AEPSC Childress Area Transmission Improvement Project – ERCOT Independent Review Project Update

RPG Meeting
October 28, 2025

Introduction

Option 1A: Modification to Option 1

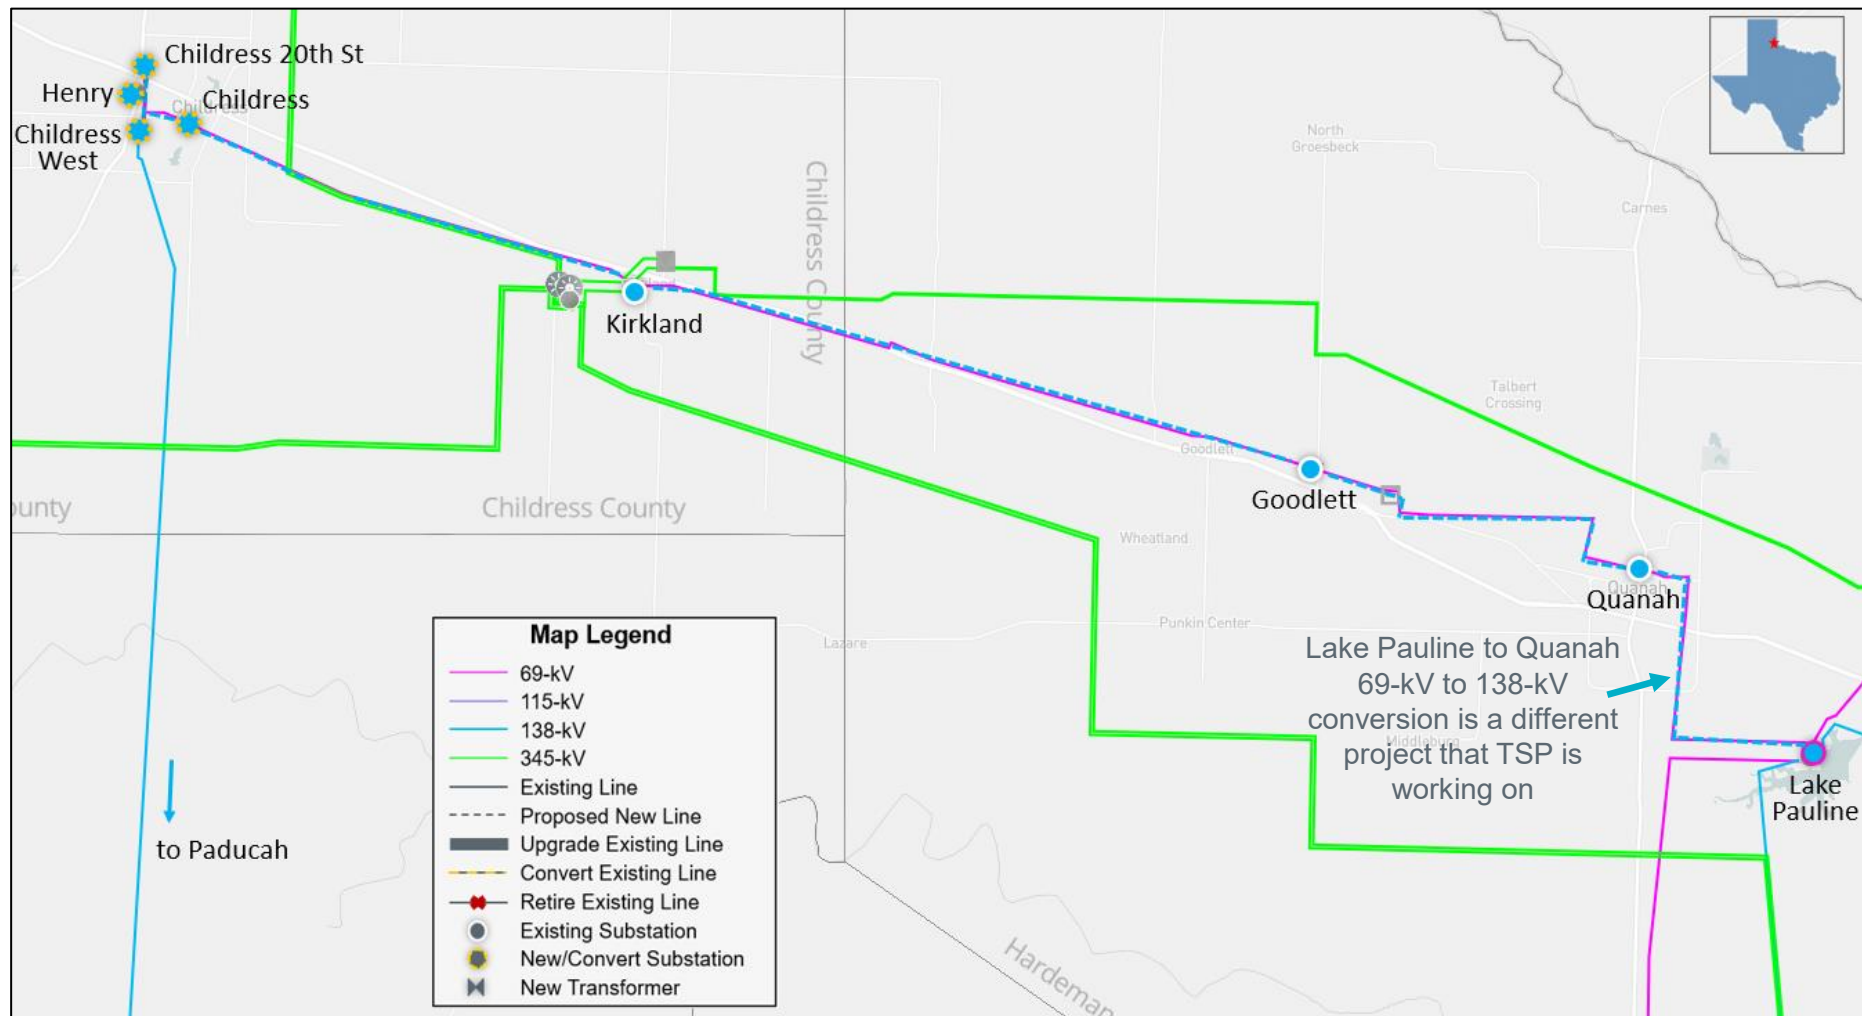
- Construct a new 138/69-kV substation (New Substation) by cutting into the existing West Childress to Paducah 138-kV transmission line
 - Install one 138/69-kV transformer with normal and emergency ratings of at least 90 MVA

- The 138-kV substation will have a ring bus design
 - The 69-kV substation will have a single bus design
- Loop the existing Childress to Quanah 69-kV transmission line between the Childress to Kirkland substations into the New Substation

- Construct two new transmission lines (one 69-kV transmission line with normal and emergency ratings of at least 52 MVA and 67 MVA, respectively, and one 138-kV transmission line with normal and emergency ratings of at least 278 MVA and 408 MVA, respectively) on double-circuit structures from the cut-ins to the New Substation, which will require a new right of way (ROW), approximately 3.5-mile

- Convert the existing 69-kV transmission lines and tap stations between the New Substation and Quanah to 138-kV
 - The converted Quanah to Goodlett to Kirland to New Substation 138-kV transmission lines will have normal and emergency ratings of at least 278 MVA and 408 MVA, respectively, which will require a new ROW for the transmission spans outside of Kirkland substation, approximately 0.8-mile

Map of ERCOT Recommended Option

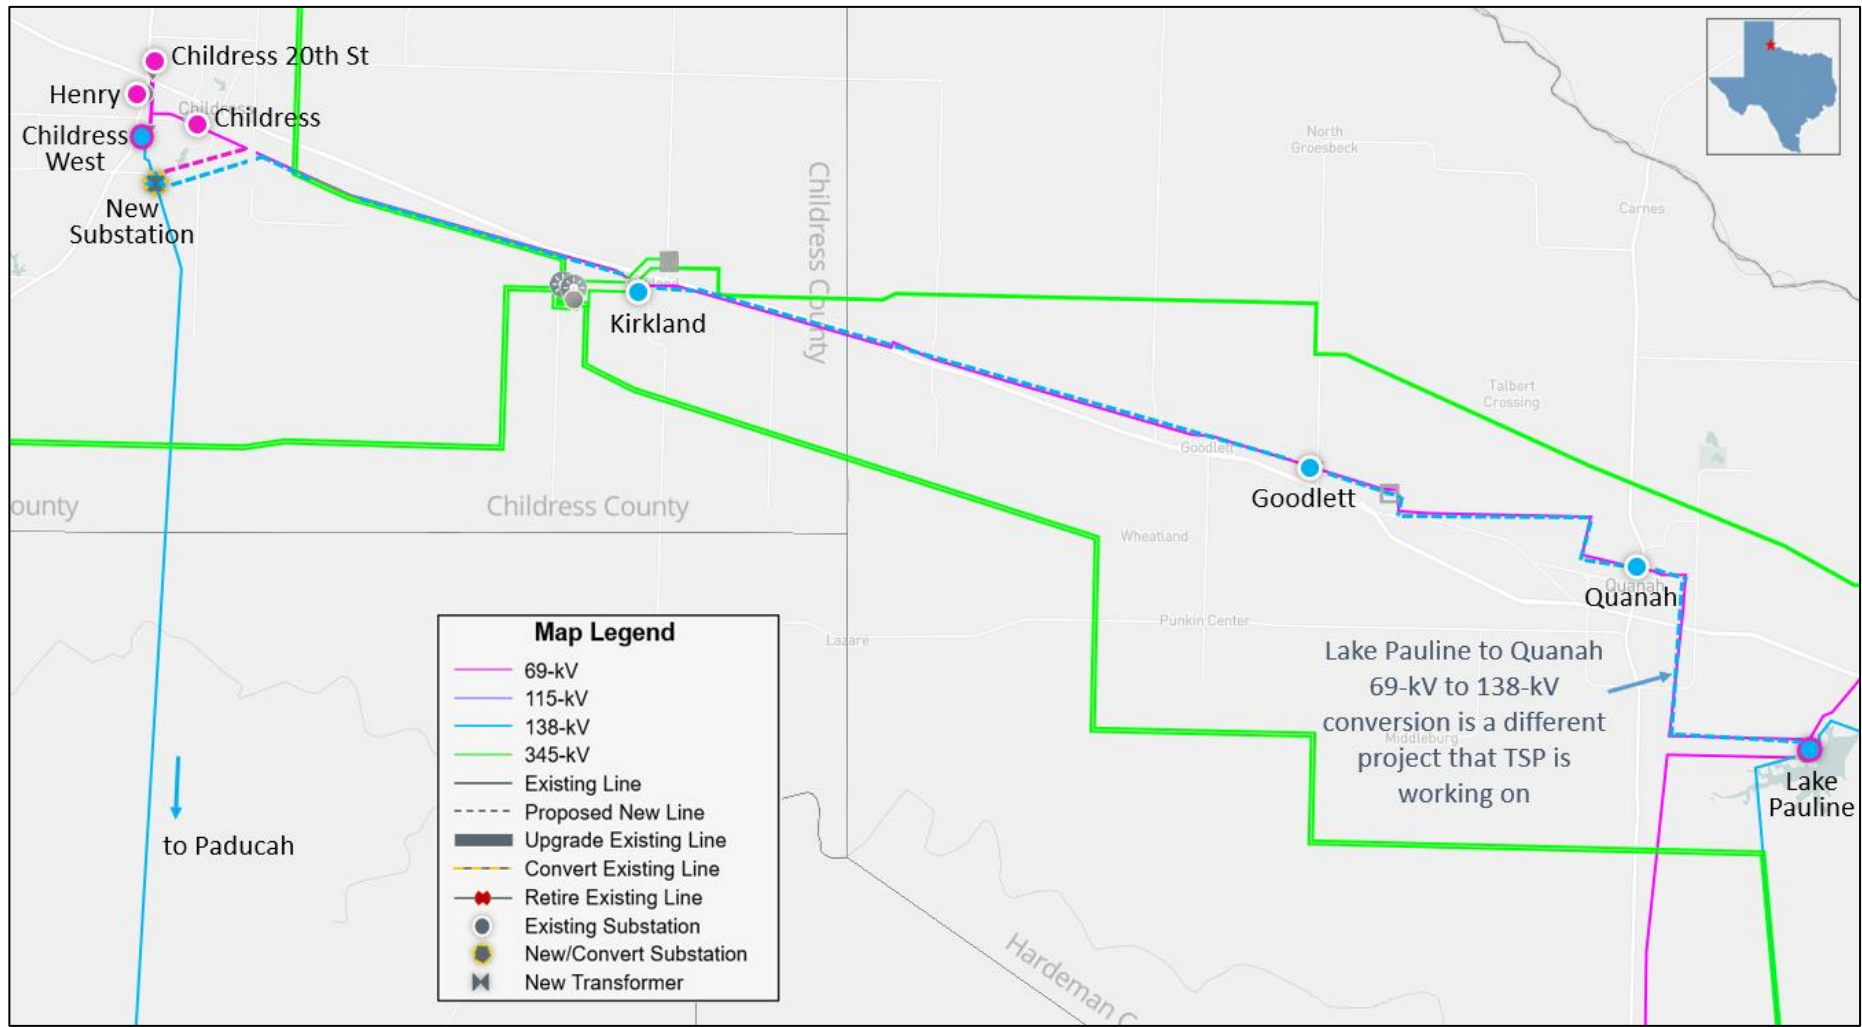
- Construct a new 138/69-kV substation (New Substation) by cutting into the existing West Childress to Paducah 138-kV transmission line
 - Install one 138/69-kV transformer with normal and emergency ratings of at least 90 MVA

- The 138-kV substation will have a ring bus design
 - The 69-kV substation will have a single bus design
- Loop the existing Childress to Quanah 69-kV transmission line between the Childress to Kirkland substations into the New Substation

- Construct two new transmission lines (one 69-kV transmission line with normal and emergency ratings of at least 52 MVA and 67 MVA, respectively, and one 138-kV transmission line with normal and emergency ratings of at least 278 MVA and 408 MVA, respectively) on double-circuit structures from the cut-ins to the New Substation, which will require a new right of way (ROW), approximately 3.5-mile

- Convert the existing 69-kV transmission lines and tap stations between the New Substation and Quanah to 138-kV
 - The converted Quanah to Goodlett to Kirland to New Substation 138-kV transmission lines will have normal and emergency ratings of at least 278 MVA and 408 MVA, respectively, which will require a new ROW for the transmission spans outside of Kirkland substation, approximately 0.8-mile

- ERCOT recommends Option 1A
 - Estimated Cost: approximately \$77.3 million
 - Expected ISD: November 2031
 - CCN filling will be required to
 - Construct the new 138-kV and 69-kV double-circuit line from the New Substation to the structure 4/5, requiring approximately 3.5-mile new ROW
